AMENDMENTS TO DRAWINGS

REMARKS

Figure 2A

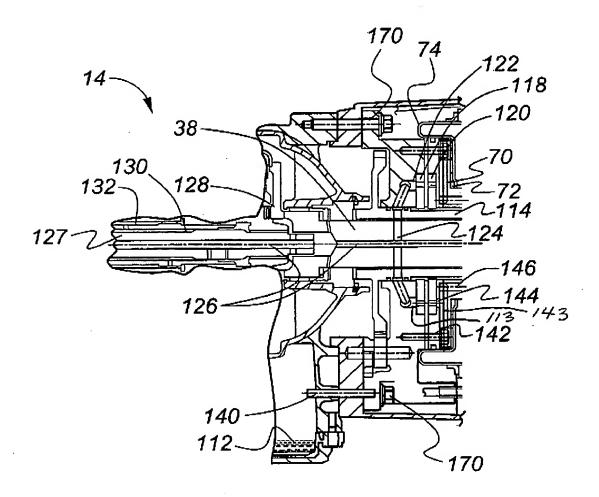
Figures 2A and 2B have been marked with changes. In Figure 2B the lead line from "164" has been extended to the radial passage as shown and skewed passage 111 connecting sump 110 and the inlet 113. In Figure 2A the inlet of scavenge pump 118 has been identified by reference number "113" and the radial passage connecting axial passages 142, and 146 has been identified by reference number "143".
